CHRISTOPHER LTD

REVISION:	FILE NAME	JOB NO.	DATE
05.03.02	C-LTD C-1		
SHEET TITLE:			DRAWN
GRADING & DRAINAGE PLAN			MRK

RE: 1701 Aspen N.W./ PHASE 1

GRADING/DRAINAGE PLAN

GRADING AND DRAINAGE PLAN

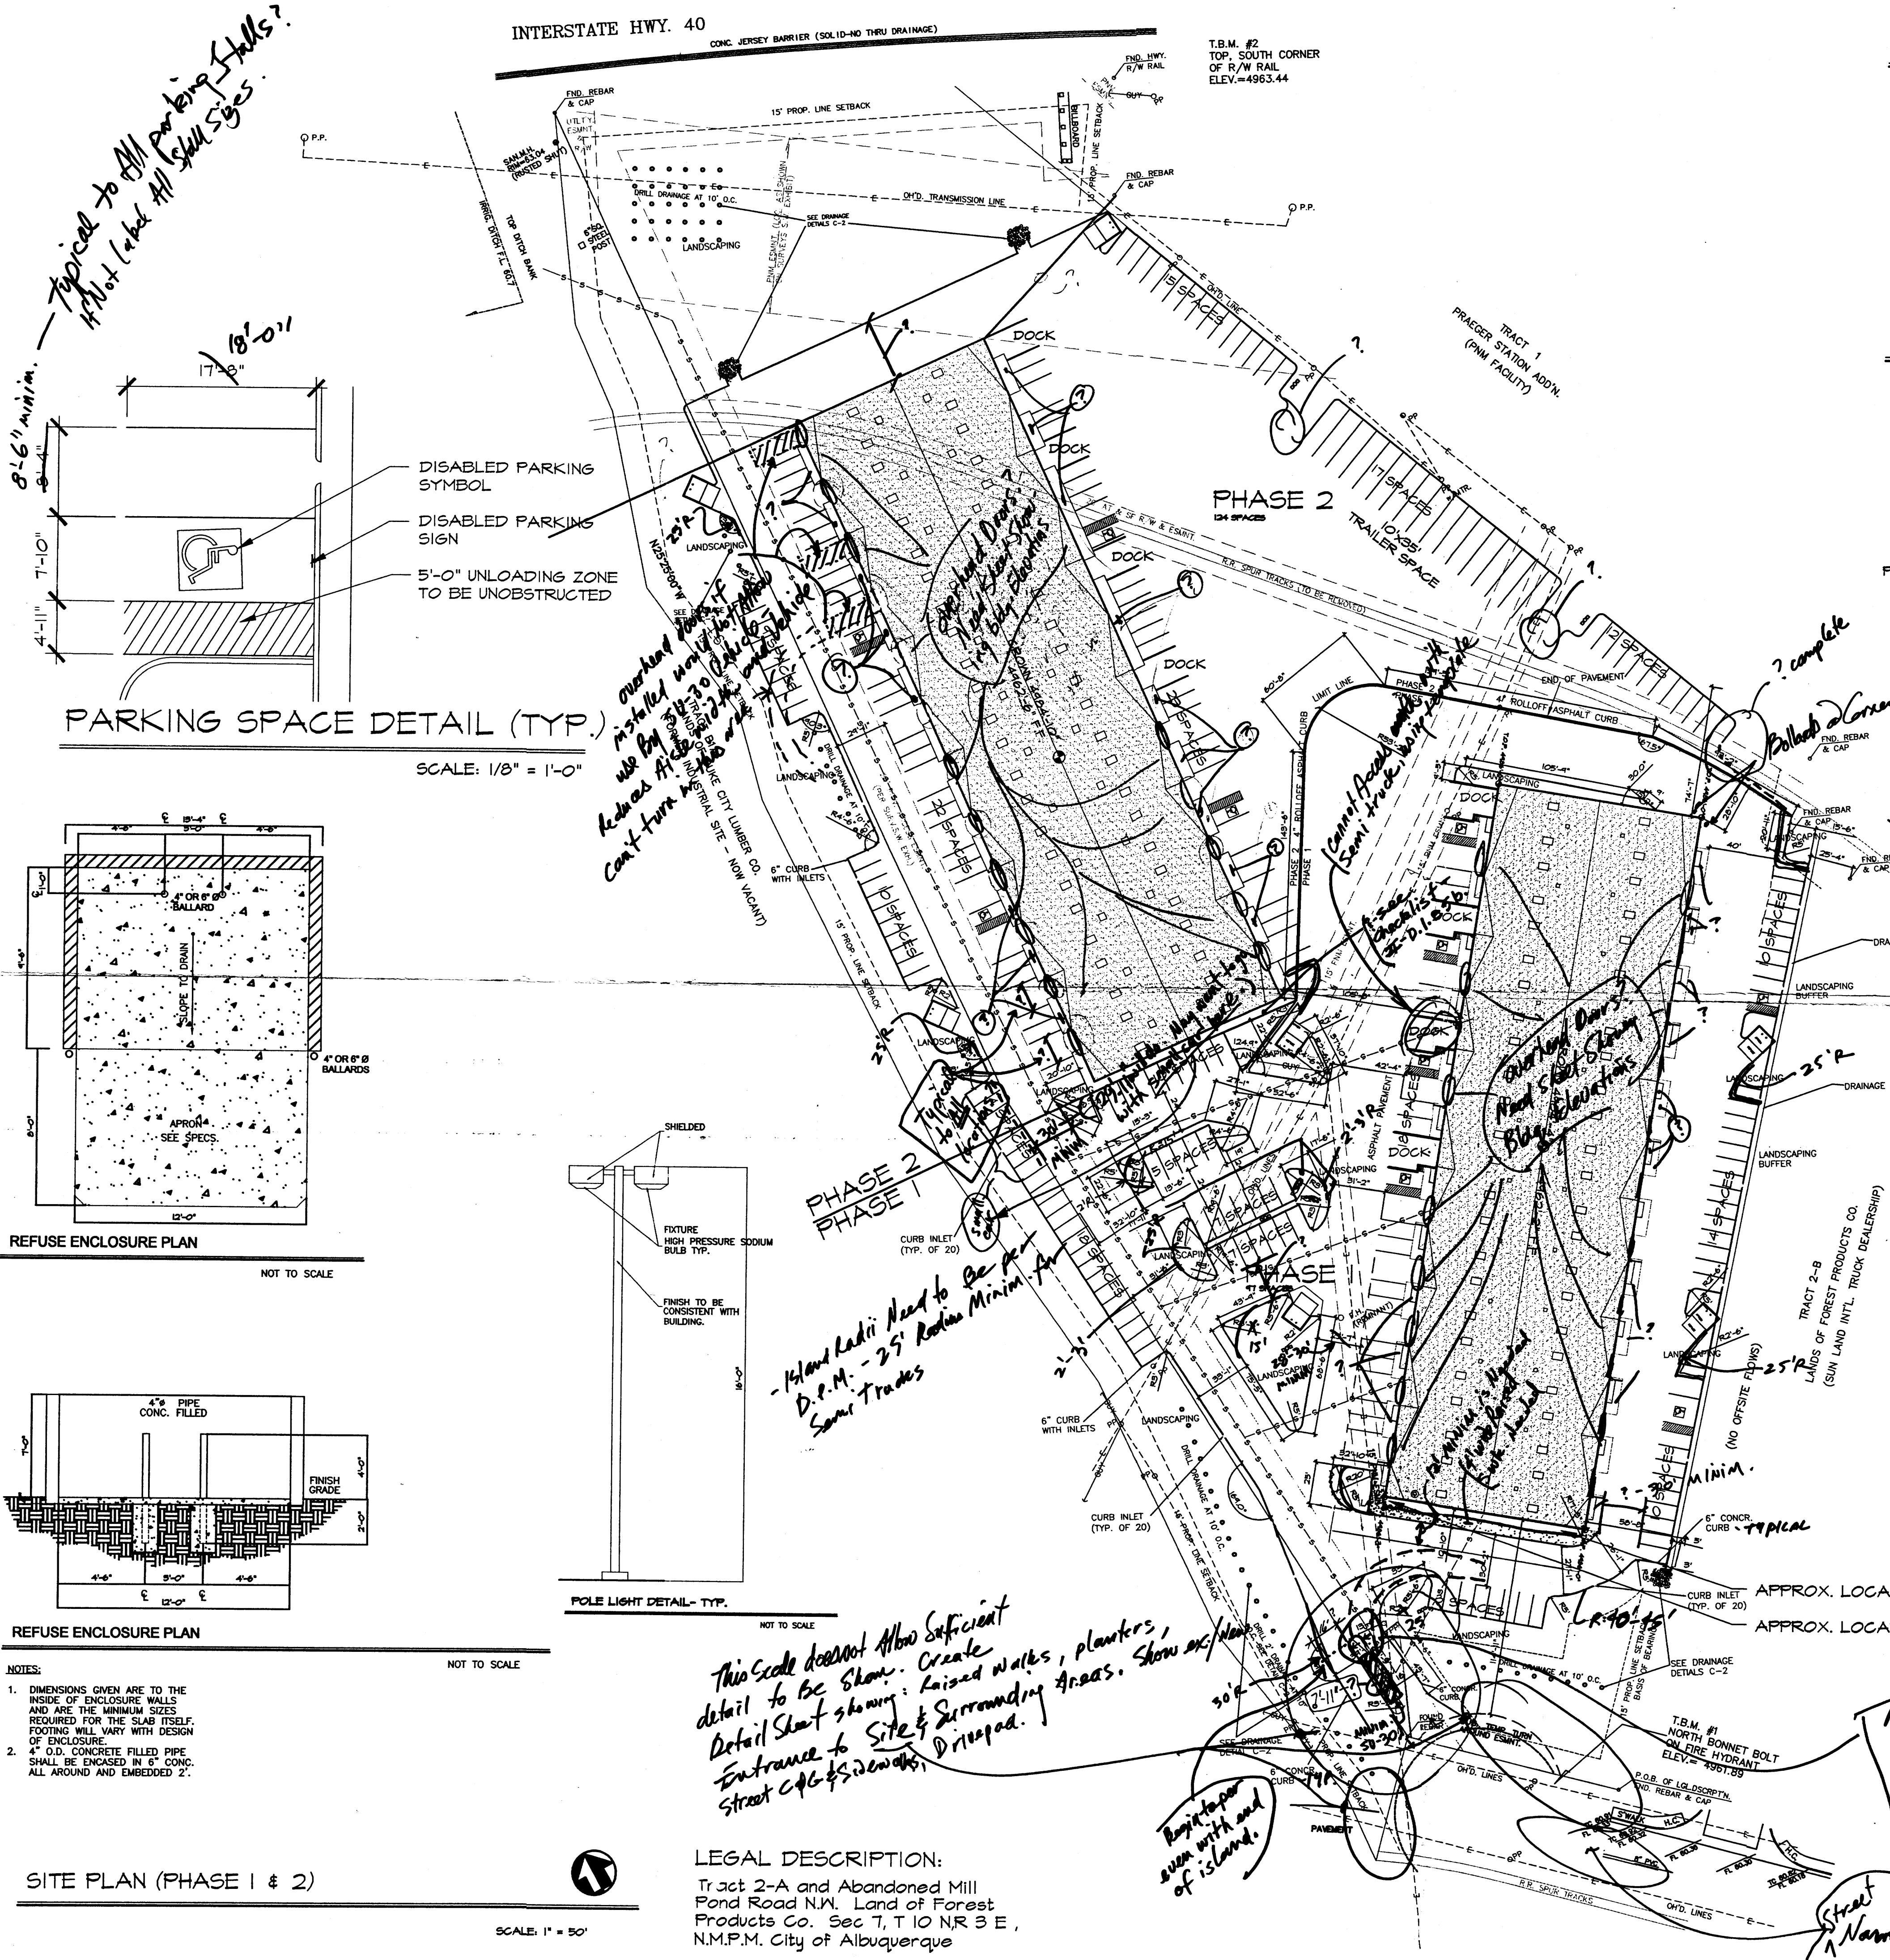
no drilling
provide permission
to build in Abn
mill pond Rd.
!! s/s & water in
road

THIS IS ONLY
FOR PHASE 1
- DO YOU ONLY
WANT B.P. APPROVAL
FOR PHASE 1
OR PHASE 1+2?
NEED TO
PUT
APPROPRIATE
SITE LOCATION?

IDENTIFY RR TRACKS
- REMOVING
FF: elevations
C-2
RR

BETTER
DETAIL
APPEARS lower
than drainage
structure.

WHAT'S HAPPENING
STREET?

STATE ALL OFF SITE FLOWS.

GRADING AND DRAINAGE PLAN

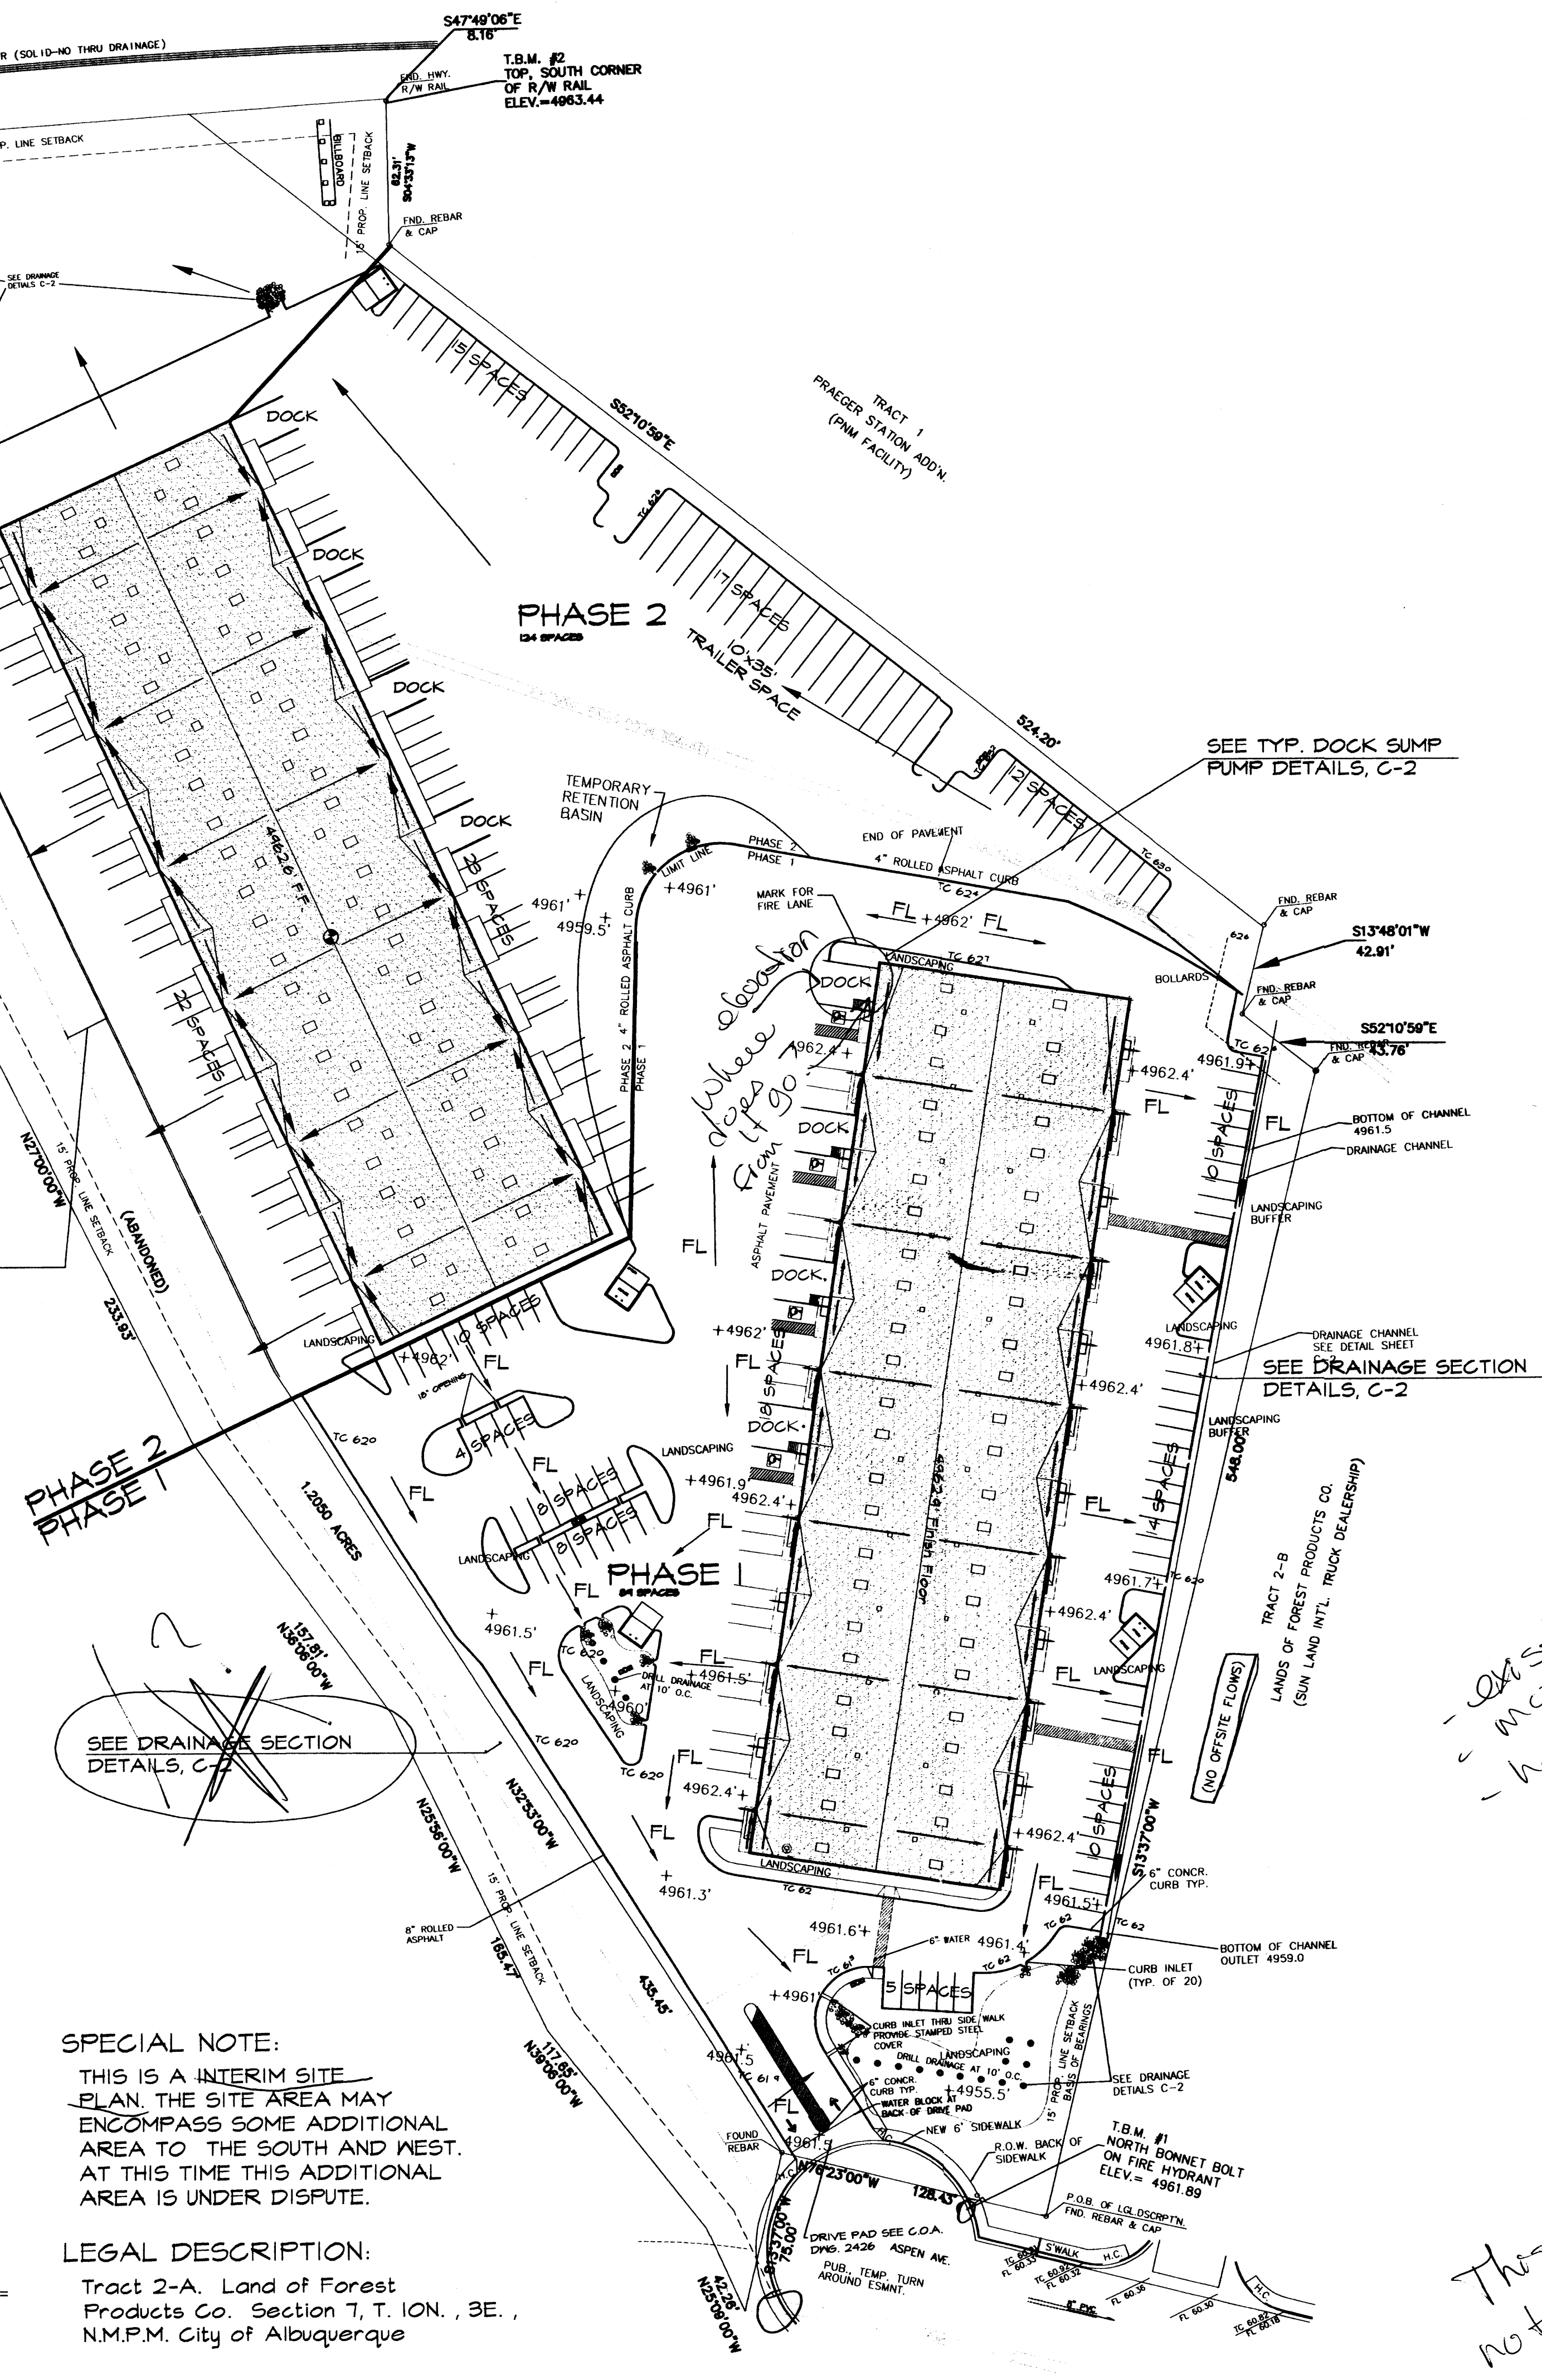
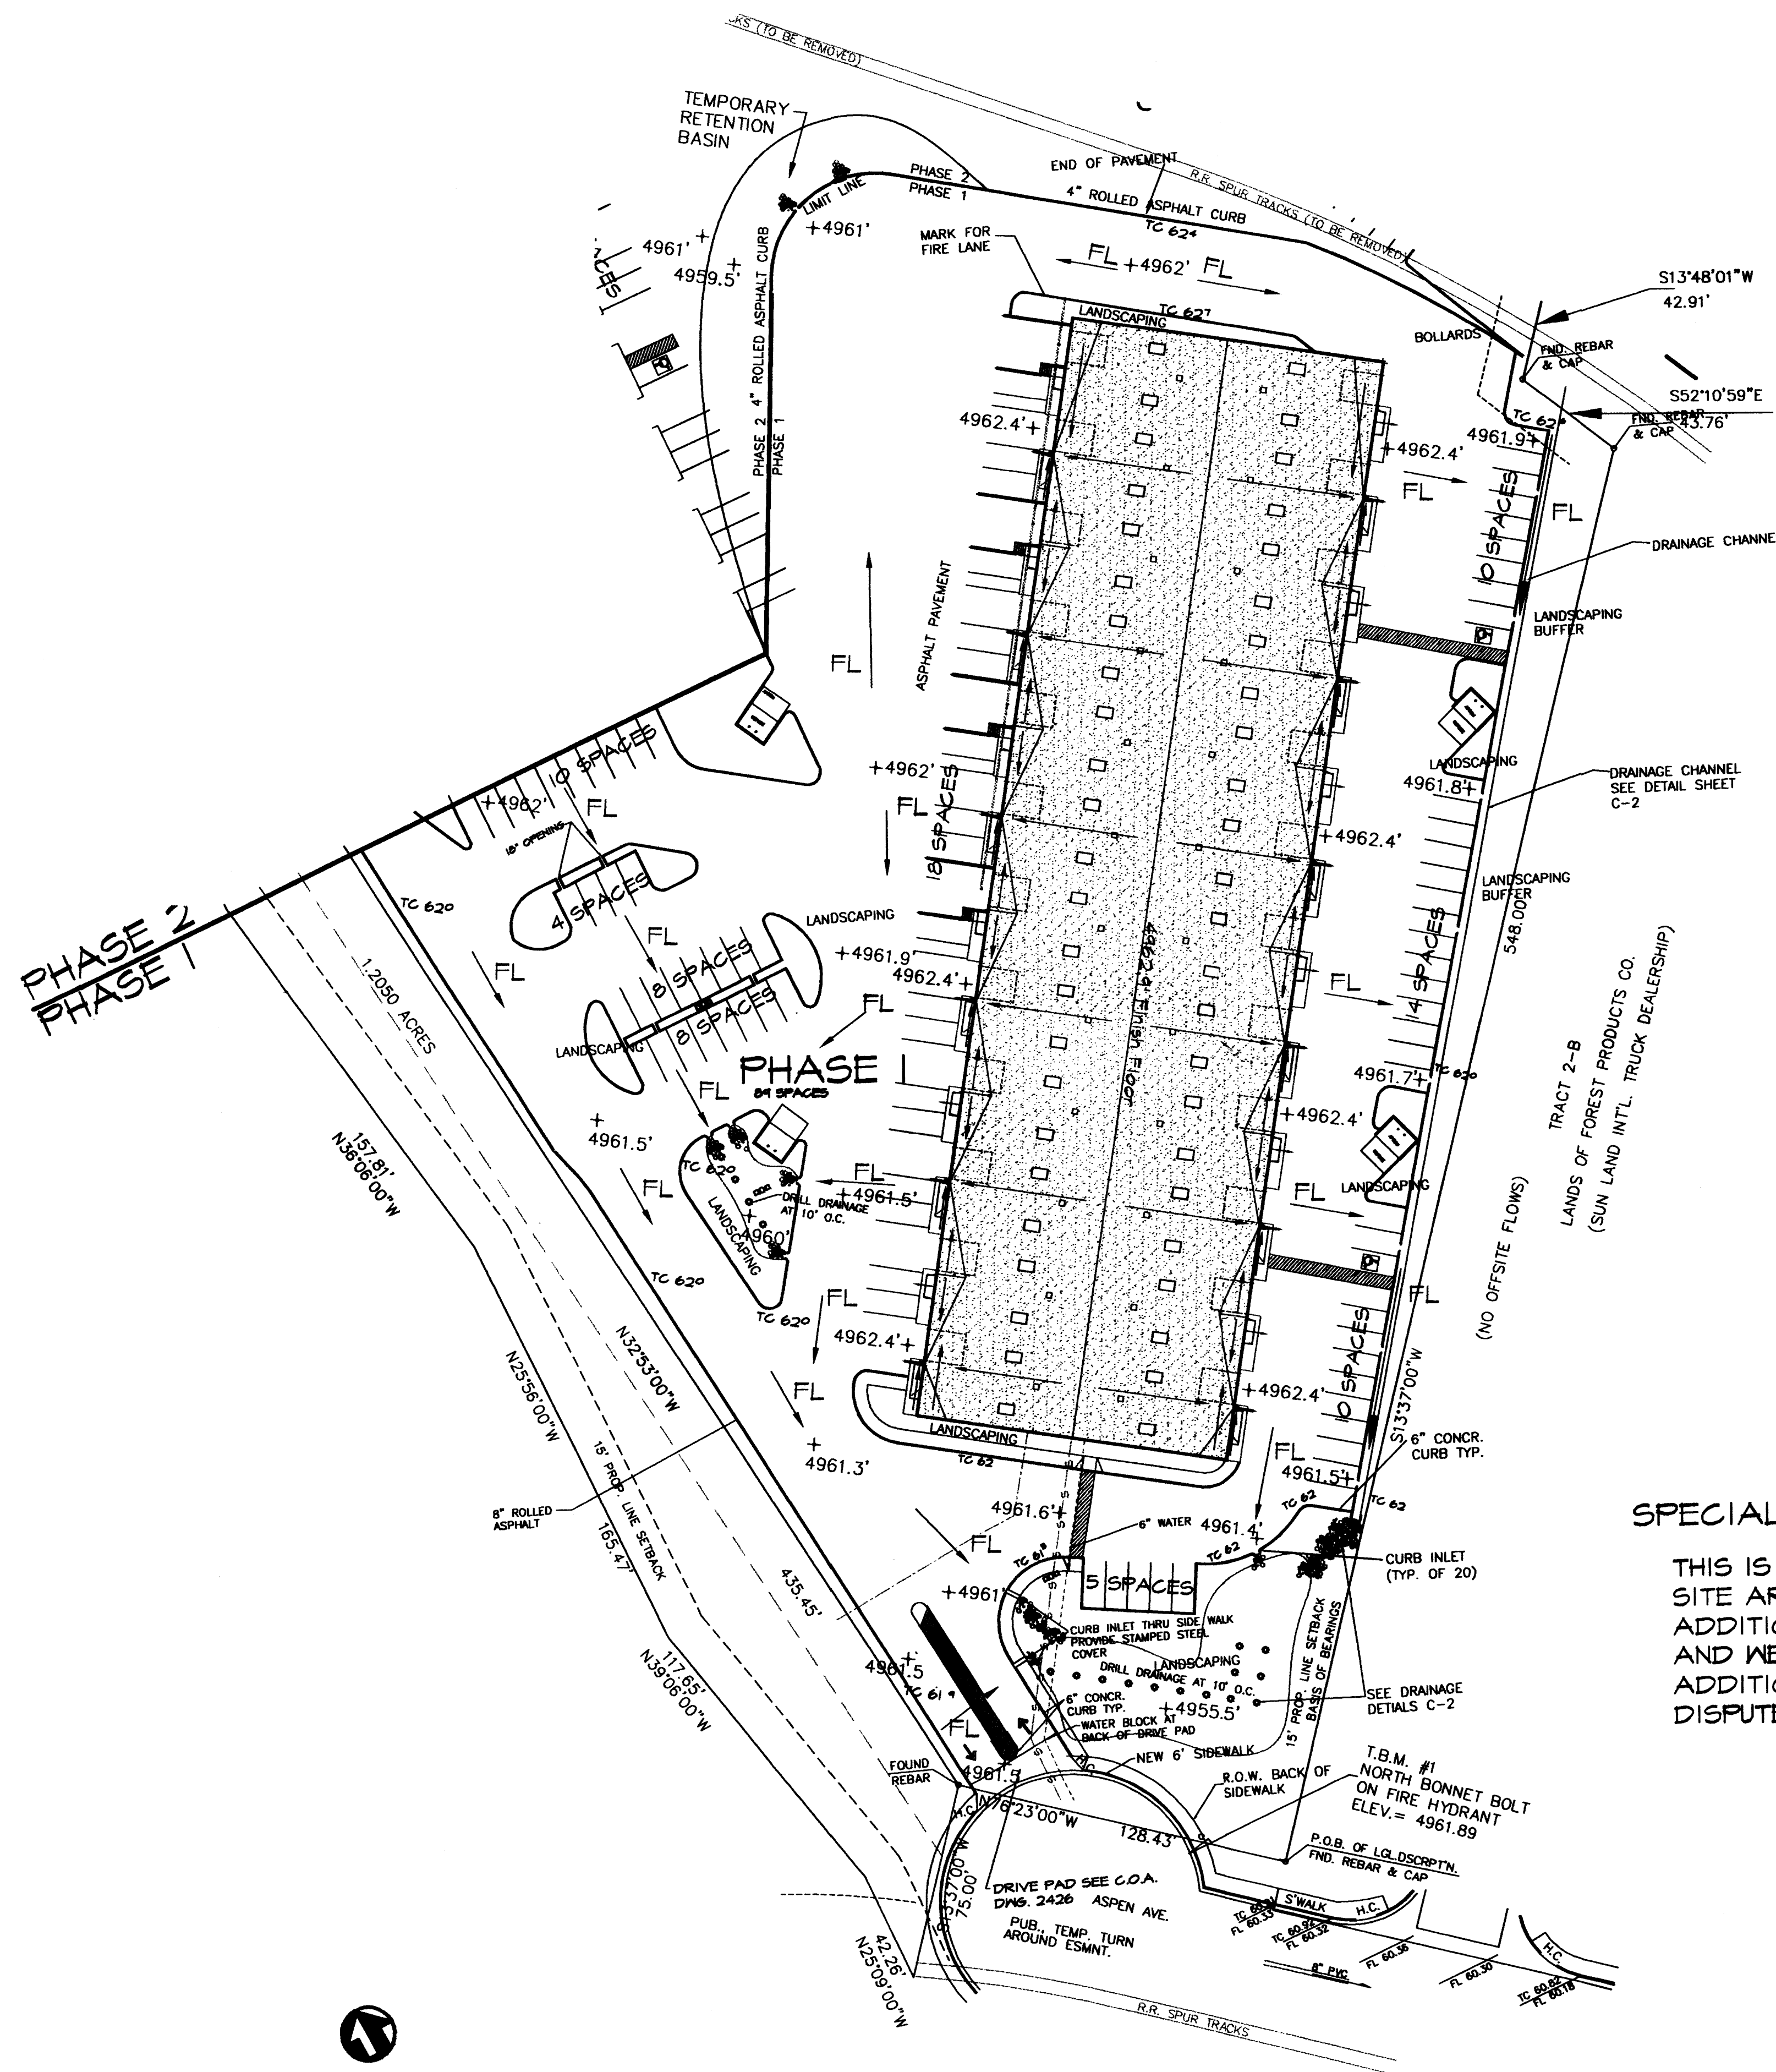
WEIGHTED E = $[0.53 (1.007) + 0.78 (0.00) + 1.13 (0) + 2.12 (3.530)] / 4.617$ AC.
= 1.723 IN. *NO*

What is peak discharge?

existing contours
more spot elevations
how does dock
work - detail?
- FL TC

This plan is
not buildable
